Group 2 Body Structure

Service Bulletin

NUMBER 2902-30001

FIGURE 3. UPPER STRUCTURE TO FRAME REINFORCEMENT.

FIGURE 1. TYPICAL SECTION AND FRAME CONDITIONS.

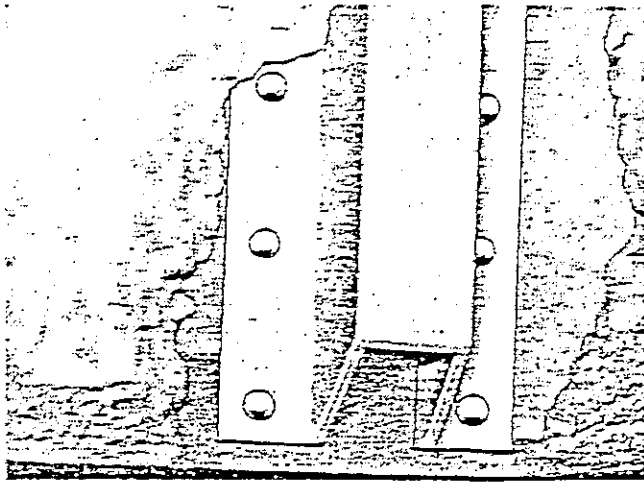
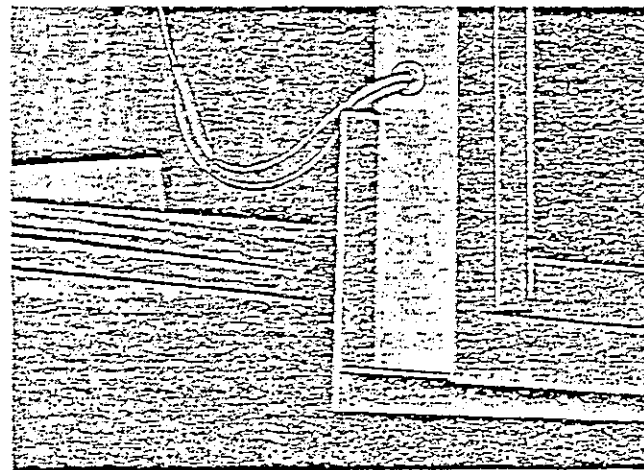
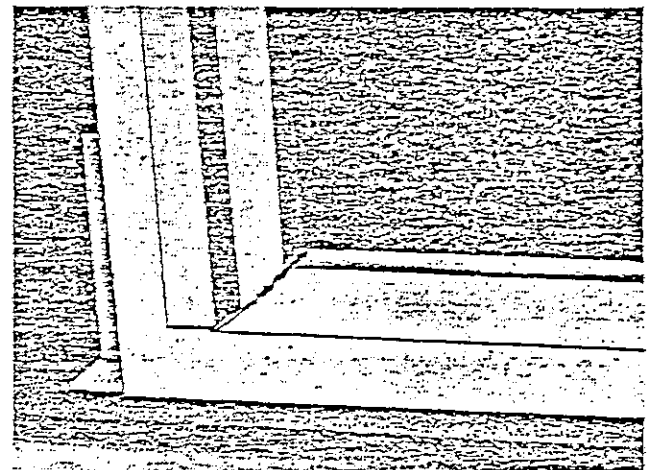
(A) Good section at frame proper cut-away of foam for rivet inspection

(B) Right front section with missing rivets

(C) Right rear support section pulled away from lower frame

(D) Left rear support section pulled away from lower frame

(E) Passenger door frame pulled away from lower frame

(F) Hairline crack lower aft corner of passenger frame

<p>ATTENTION: SERVICE MANAGER</p>	<p>GROUP 2</p>
<p>3. Inspect all body section to frame mounts and door for missing rivets, possible movement or disfiguration of rivets (Figure 2) or movement of body section or door frame away from lower frame (Figures 1 and 3).</p> <p>4. Inspect shear panels for missing rivets, possible movement or disfiguration of rivets (Figure 2) or movement of shear panel away from upper body sections. Note: If rivets show signs of movement, add two new rivets between each pair of existing rivets as shown in Figure 2.</p> <p>5. If all upper body section to lower frame rivets are in place and show no signs of deterioration, no reinforcement is necessary <u>except</u> at the right and left body sections (L4 and R4, Figure 3) forward of the rear wheels. New frame reinforcing angles will be added at these points regardless of the condition of the existing section and rivets.</p>	<p>SUBJECT Frame Reinforcement Instructions</p>

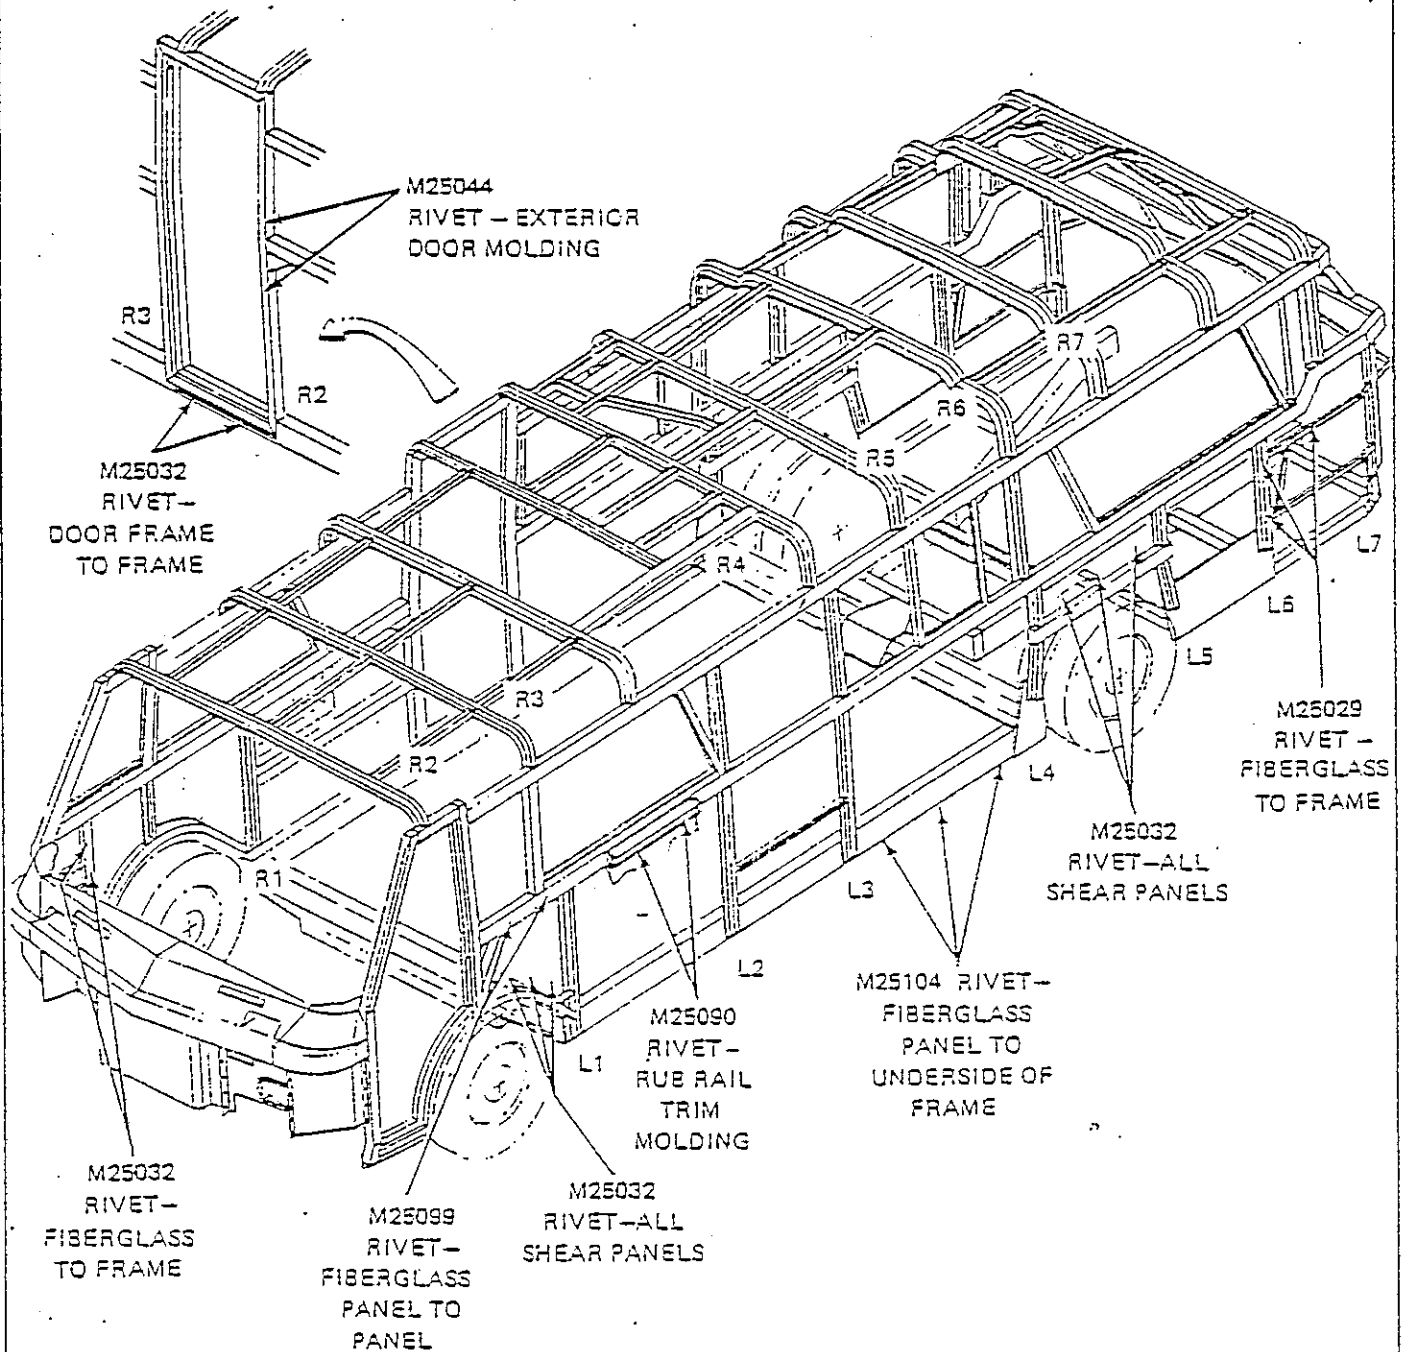
<p>ATTENTION: SERVICE MANAGER</p>	<p>GROUP 2</p>
<p>Condition 1 - Right and left sections forward of rear wheels (positions L4 and R4 in Figure 3) need reinforcement ---4 man hours. Please note that it is not necessary to completely remove coach panels to reinforce for this condition (see Joint Reinforcement Figure 5).</p>	<p>SUBJECT Frame Reinforcement Instructions</p>
<p>Condition 2 - Right and left sections forward of rear wheels (L4 and R4) and all right side sections between rear wheel and front wheel (R3, R2 and R1) plus shear panels in front and rear right side wheel wells (see Figure 3) need reinforcement---8 man hours.</p>	<p>MODEL (S) AFFECTED All Motor Homes 00001 to 01050 Model 2900R</p>
<p>Condition 3 - Right and left sections forward of rear wheels (L4 and R4), all right side sections between rear wheel and front wheel (R3, R2 and R1) plus shear panels in front and rear right side wheel wells and left side sections rear of front wheel (L1, L2 and L3), plus shear panels in front and rear left side wheel wells (see Figure 3) need reinforcement. Call factory service representative 408-289-3665 regarding warranty reimbursement <u>before</u> proceeding with the work.</p>

<p>Condition 4 - Right and left sections forward of rear wheels (L4 and R4), all right side sections between rear wheel and front wheel (R3, R2 and R1) plus shear panels in front and rear right side wheel wells and left side sections rear of front wheel (L1, L2 and L3), plus shear panels in front and rear left side wheel wells, and all four corners of passenger door frame (see Figure 3) need reinforcement. Call factory service representative 408-289-3665 regarding warranty reimbursement <u>before</u> proceeding with the work.</p>	
<p><u>INSPECTION</u></p> <p>A thorough inspection of each coach is essential before proceeding with the work to determine if all parts and equipment are in stock and to determine extent of frame reinforcement required.</p> <ol style="list-style-type: none"> 1. Release lower edge of fiberglass side panels on left and right sides of coach (see Figure 5). 2. Cut away foam insulation just enough to inspect all rivets on body sections and shear panels (Figure 1A).

<p><u>ACCOMPLISHMENT INSTRUCTIONS</u></p> <p>A. <u>Hull Section to Frame Angles</u> (Figure 3, positions L4, R4, R2 and R3)</p> <ol style="list-style-type: none"> 1. Make certain coach is level at all four jacking points. Jack up body until distance from horizontal strut (just forward of right rear wheel) to bottom of frame is 39 to 39 1/4" as shown in Figure 4. 2. Realign rivet holes as close as possible. 3. Close gap between upper body section and lower frame with C clamp. 4. Cut out shear panel only as necessary to install reinforcing angles. 5. Grind or file off existing rivet heads to make angles flush with shear panel. 6. Apply zinc chromate primer to reinforcing angles in all areas that come in contact with aluminum. 7. Place reinforcing angles (5109097-01) against the body section and flush with lower frame. Secure with C clamps. 	<p>MODEL (S) AFFECTED</p> <p>All Motor Homes 00001 to 01050 Model 2900R</p>

FIGURE 5. REINFORCING ANGLES.

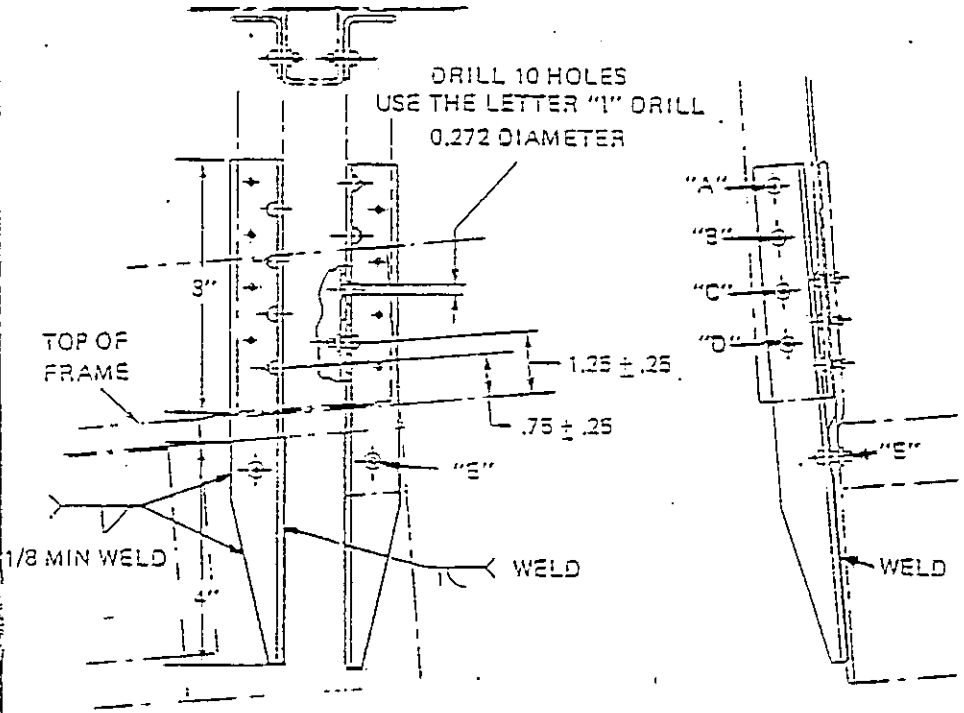
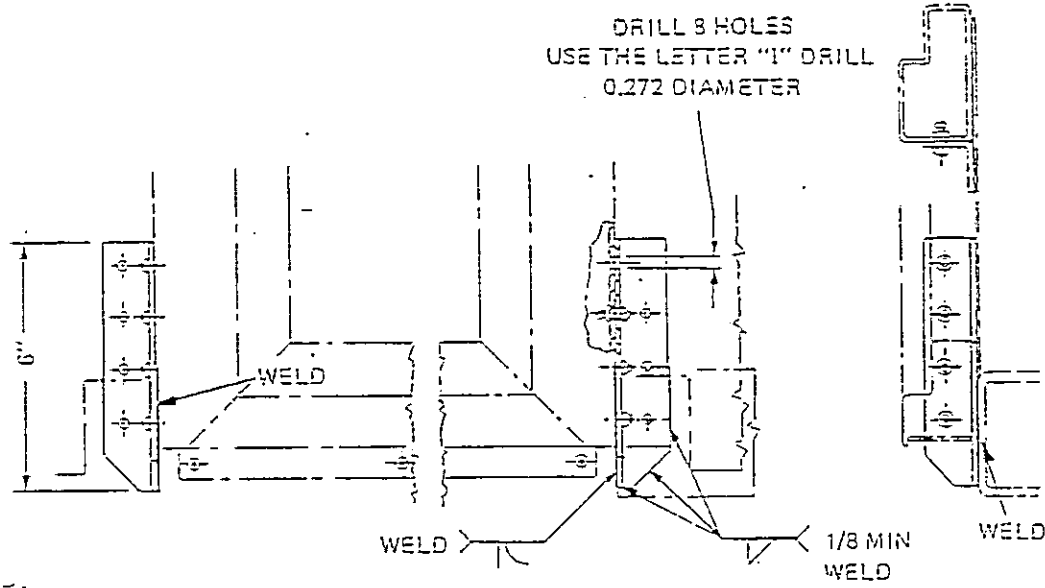
ATTENTION: SERVICE MANAGER	GROUP 2						
<p>8. Drill two holes through each angle, one into body section and one onto the lower frame at points "D" and "E" in Figure 5. Use an "I" size drill.</p> <p>9. Install one fastener (5109247-04, colored red) through body section and lower hole of angle ("D" in Figure 5) to secure each angle. Use special "Huck" gun on fastener.</p> <p>10. Install one fastener (5109247-05, colored yellow) through frame and lower hole of angle ("E" in Figure 5) to secure angle at position L4 only (see Figure 3).</p> <p>11. Install one fastener (5109247-05, colored yellow) through frame and lower hole of angle ("E" in figure 5) to secure angle at position R4 only (see Figure 3). Use special "Huck" gun on fastener.</p> <p>12. Drill three holes through each angle into body sections for positions "A", "B" and "C" in Figure 5. Use an "I" size drill.</p> <p>13. Install fasteners (5109247-04, colored red) through body section to secure each angle. Use special "Huck" gun on fastener.</p> <p>14. Remove paint and scale in areas to be welded. Degrease using small disc sander or wire brush prior to welding.</p> <p>15. Weld angle to lower frame as indicated in Figure 5. A metal to metal fit is desirable. If gap exists, make two welding passes.</p>	SUBJECT Frame Reinforcement Instructions						
<p>B. <u>Hull Section to Frame</u> (Figure 3, positions L1, L2, L3, L5, L6, L7 and R1, R5, R6 and R7)</p> <p>1. Drill out old rivets and replace with "Huck" fasteners per table listed below:</p>

<p>2. Realign rivet holes as close as possible.</p> <p>3. Close gap between body section and lower frame with C clamp.</p>	<u>Position</u>	<u>Fastener</u>	L1, L2, L3, L5, L6, L7	5109247-05, colored yellow	R1, R5, R6, R7	5109247-07, colored brown	MODEL (S) AFFECTED All Motor Homes 00001 to 01050 Model 2900R
<u>Position</u>	<u>Fastener</u>						
L1, L2, L3, L5, L6, L7	5109247-05, colored yellow						
R1, R5, R6, R7	5109247-07, colored brown
